Docket Item #15
DEVELOPMENT SPECIAL USE PERMIT #2008-0008
621 NORTH PAYNE STREET

Planning Commission Hearing
September 4, 2008

REQUEST: Consideration of a request for an amendment to DSUP2005-0014 to adjust the unit mix and add a loading bay.

LOCATION: 621 North Payne Street

Figure 3: Floor Plan with Central Corridor

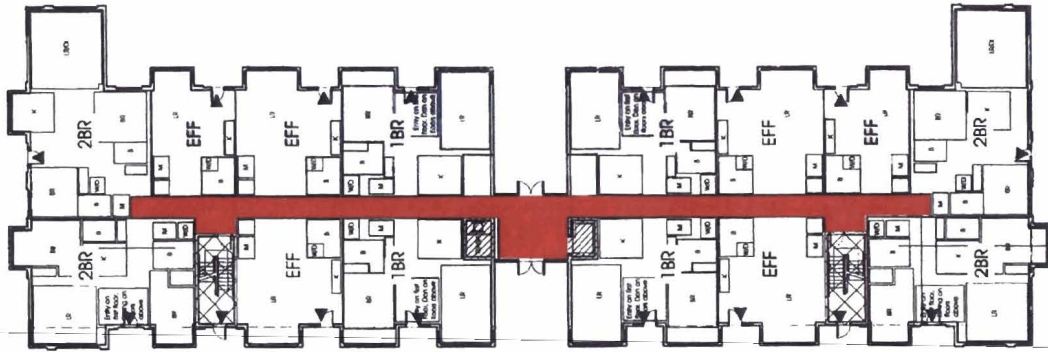
The units on Wythe Street are accessible from a central corridor internal to the building. Each of the ground-floor units also has a functional entrance that fronts the public right-of-way and a front yard.

Staff discussed the elimination of the corridor at length with the applicant, but determined that the corridor was necessary for several reasons, including accessibility and refuse removal. Furthermore, while many residents are likely to access their unit from the central corridor, staff anticipates that ground-floor residents will utilize their individual entrances, particularly when walking from nearby amenities such as the Braddock Road Metro Station, the post office, and other daily activities.

Figure 4: Previously Approved Floor Plan

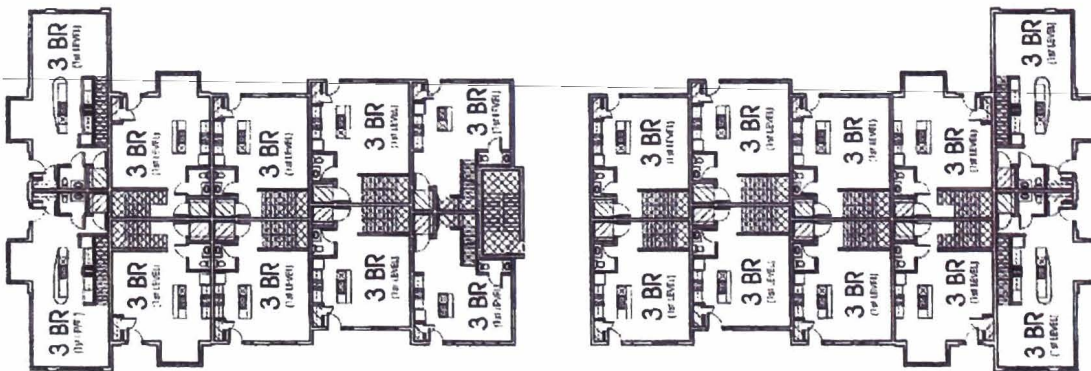
In addition, community members also expressed concern with the decrease in unit size. Many expressed concerns that the decreased size may alter the type of residents that choose to reside in this location; encouraging single occupants, rather than families. While the residential market has driven the decrease in unit sizes, the applicant has positioned the efficiency units adjacent to larger units, to easily convert one-and two-bedroom units to two-and three-bedroom units in the event the project converts to condominiums in the future.
